CITY of NOVI CITY COUNCIL

Agenda Item 4
November 23, 2015

SUBJECT: Consideration for tentative approval of the request of Learning Care Academy, JSP15-57, for a Planned Suburban Low-Rise (PSLR) Overlay Development Agreement Application and Concept Plan. The subject property is 4.15 acres of vacant land located on the west side of Beck Road, north of Eleven Mile Road, in Section 17. The applicant is proposing a child care facility to serve up to 170 children.

JSP 15-57 Learning Care Academy

SHEET NUMBER
C2.0

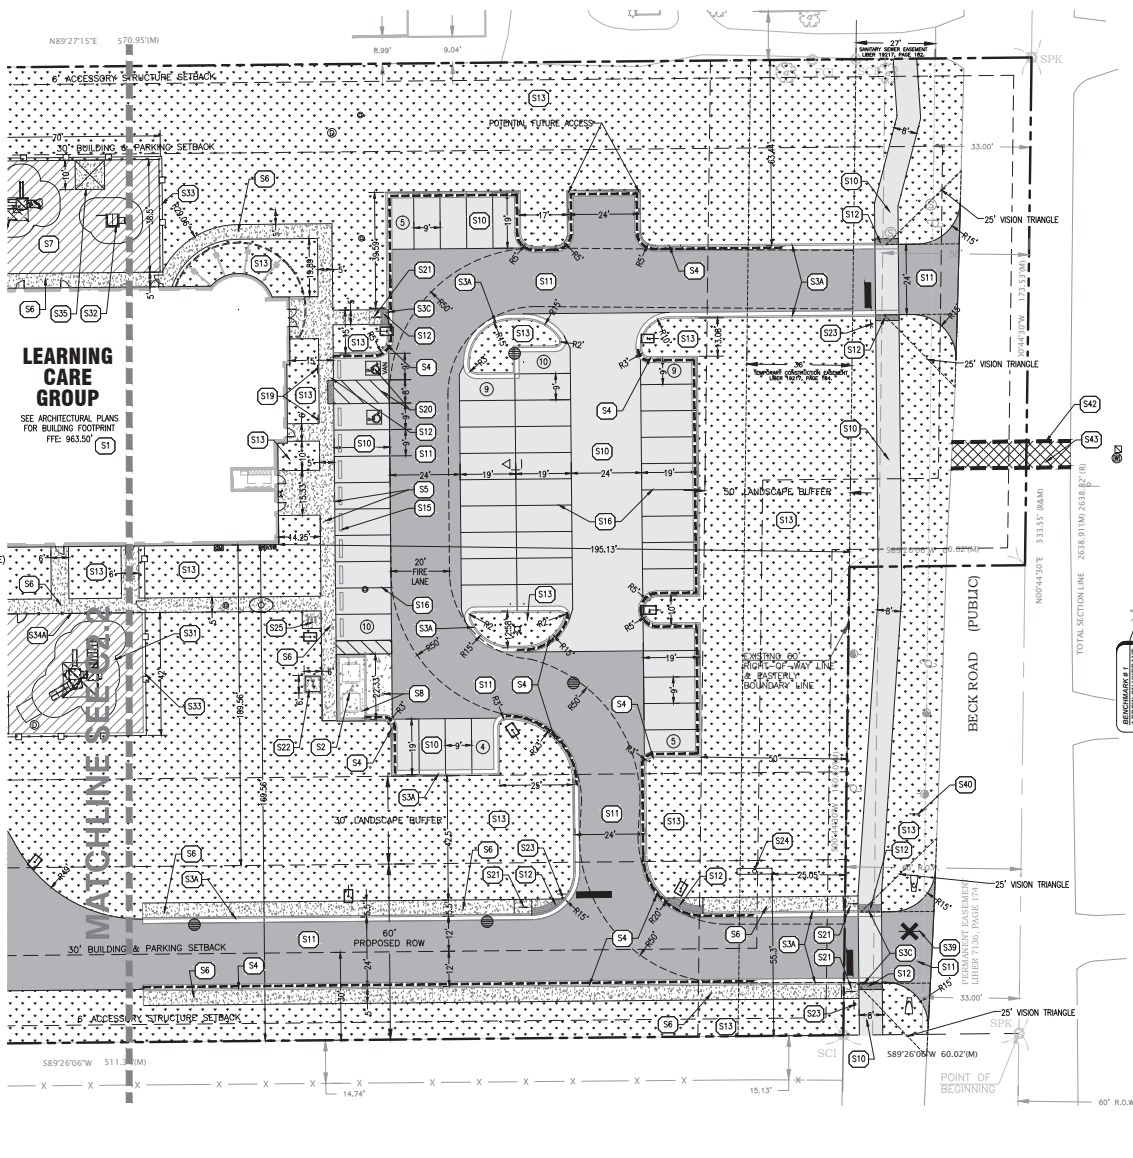
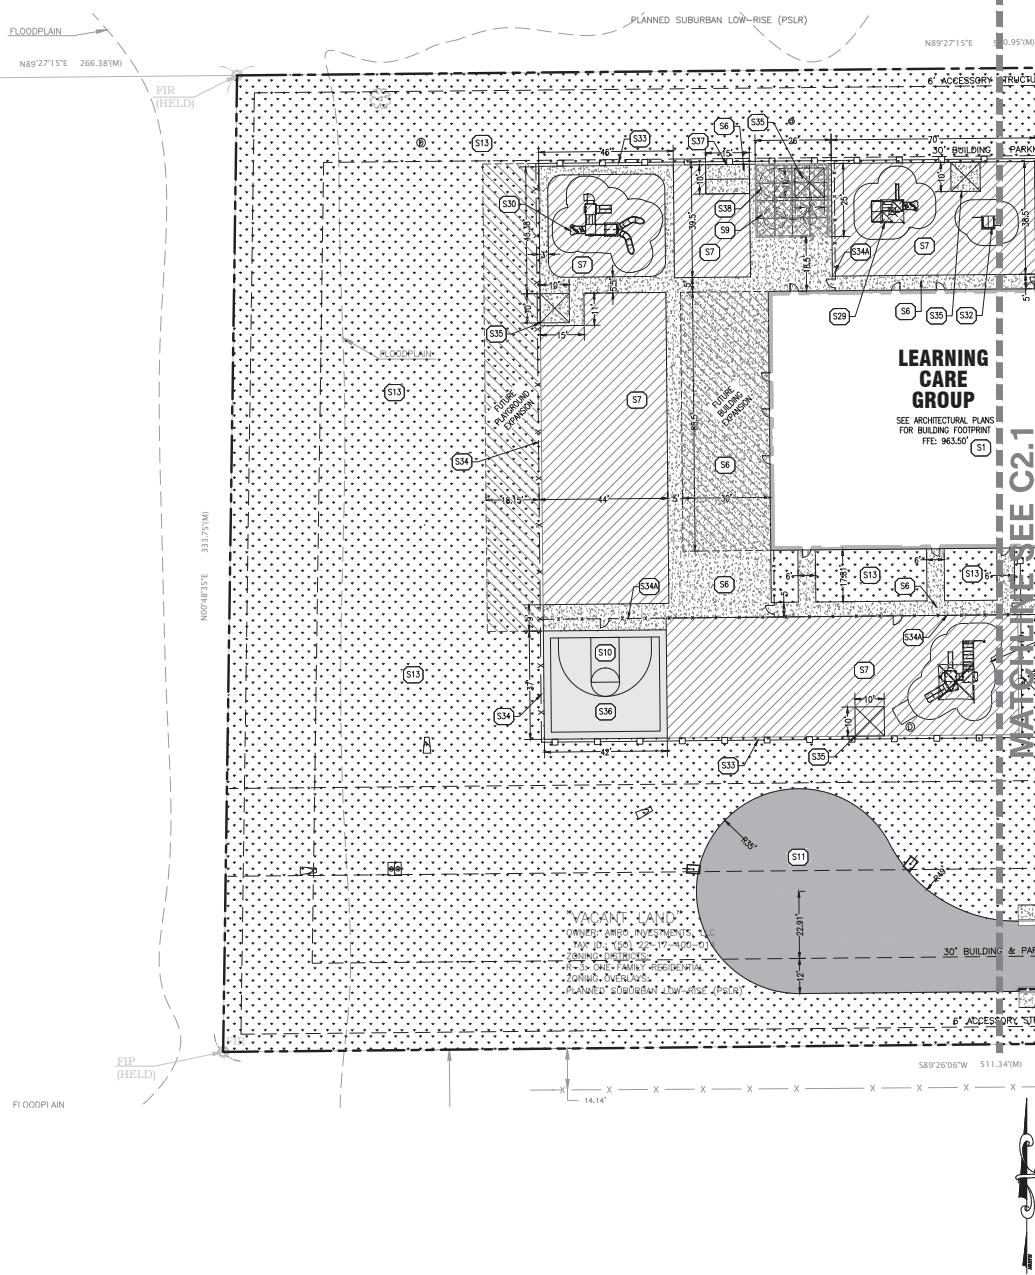
1. **Building Setbacks** (Sec. 3.21.2.A.ii) & (Sec 3.1.27.D): *Front yard or exterior side yard adjacent to roads and drives (other than planned or existing section line road rights-of-way) - minimum of thirty (30) feet and a maximum of seventy-five (75) feet. The applicant is proposing to exceed the maximum setback by thirty nine feet and 5 inches (39' 5").* The proposed deviation is the result of creating the proposed Public road to encourage future use of the roadway for developing surrounding properties. This deviation is supported by staff.

2. **Parking spaces for all uses in the district** (Sec. 3.21.2.A.iv): *Parking shall be located only in the rear yard or interior side yard. The applicant is proposing approximately 20 spaces and related drives in the front yard (south) and the rest of the parking in the exterior side yard. Parking in exterior side yard is allowed if the yard abuts a section line road and setback 50 feet.* Front yard is the area between the property line and the farthest building facade line all along the front property line. Staff understands that the deviation is a result from applicant's intent to propose the play area separated from the road right of ways and the parking lot. This deviation is supported by staff.

3. **Number of Accessory Structures** (Sec. 4.19.2.J): *Not more than two (2) detached accessory buildings shall be permitted on any lot having twenty-one thousand seven hundred eighty (21,780) square feet of area or more. The applicant is proposing three canopies within the play area.* Staff understands that the deviation is a result from daycare program requirements to provide shade from the sun. This deviation is supported by staff.

Fire recommends approval noting that the turn-around does not meet the Fire department standards, and should be modified on future submittals. The applicant has agreed to redesign to meet the requirements.

4. **Parking spaces for all uses in the district** (Sec. 3.21.2.A.iv): *Parking spaces and access aisles shall be a minimum of fifteen (15) feet from all buildings, except as provided in residential driveways.* The applicant is proposing not to meet the minimum by approximately 3 feet. The applicant is recommended to address this deviation either by revising the plan or provide a justification to be included in the agreement.

- a. Revised site plan showing the future building footprint
 - b. Phase lines, as applicable
 - c. Revised building elevations to verify conformance
2. Building, Parking and Accessory Setbacks (Sec 3.1.23.D): The site plan indicates the setbacks measured from the existing property line. **The setbacks are required to be measured from the proposed Rights-of-way after dedication. Please revise the drawings to indicate the same.**

- g. The applicant shall work with the City Engineer to determine the limits of future Right of Way around the proposed turn around;
- h. The applicant shall revise the plan to redesign the turnaround to meet the Fire department standards;

RIGHT (NORTH) SIDE ELEVATION
SCALE: 1/8" = 1'-0"

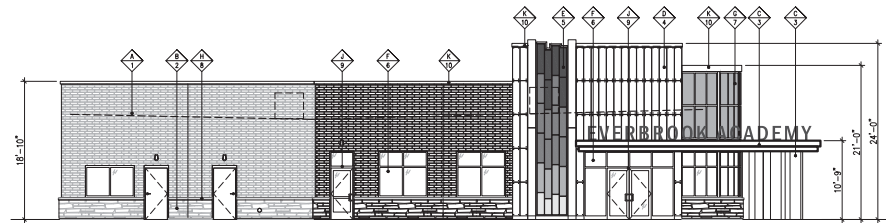
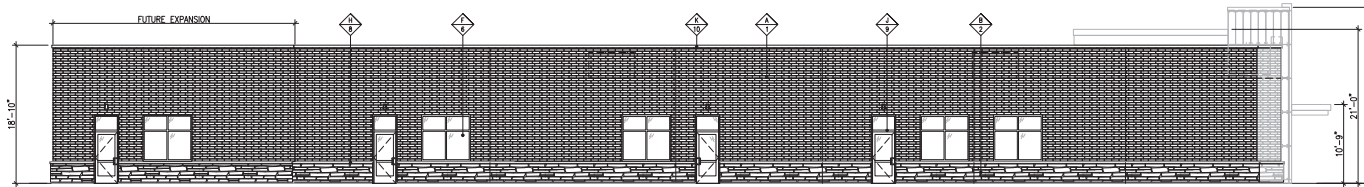
7. **Facade review:** The façade review letter states the proposed building design is in full compliance with respect to building materials, and will be compatible with the buildings in the nearby Providence Park. The review further notes that the building is commercial in nature, and does not meet the single family residential characteristics typically expected of the Planned Suburban Low Rise ordinance (i.e., sloped roofs with gables, hips, dormers, overhangs, shingles and gutters).

The PSLR Ordinance promotes a "single family residential character". The proposed design would not be in technical compliance with the ordinance. However, it is in full compliance with material requirements and is compatible with buildings located on nearby Providence Park Hospital campus. For various factors listed in the review letter, the City's Façade consultant believes that the overall design is consistent with the intent and purpose to create a transition between uses of different intensity and recommends approval. The applicant also shared the revised elevations that include the future expansion. The Façade review is unaffected. Our Façade consultant Doug Necci is here with us tonight to answer any questions the Planning Commission may

- iii. The applicant shall provide the Traffic Impact Study prior to the PSLR Agreement and Plan returning to the City Council for Final Approval;
- f. The applicant shall update the PSLR concept plan submittal to include the proposed phase lines and revised building elevations to include the future expansion as part of the PSLR concept plan, that were provided in electronic format for staff review;
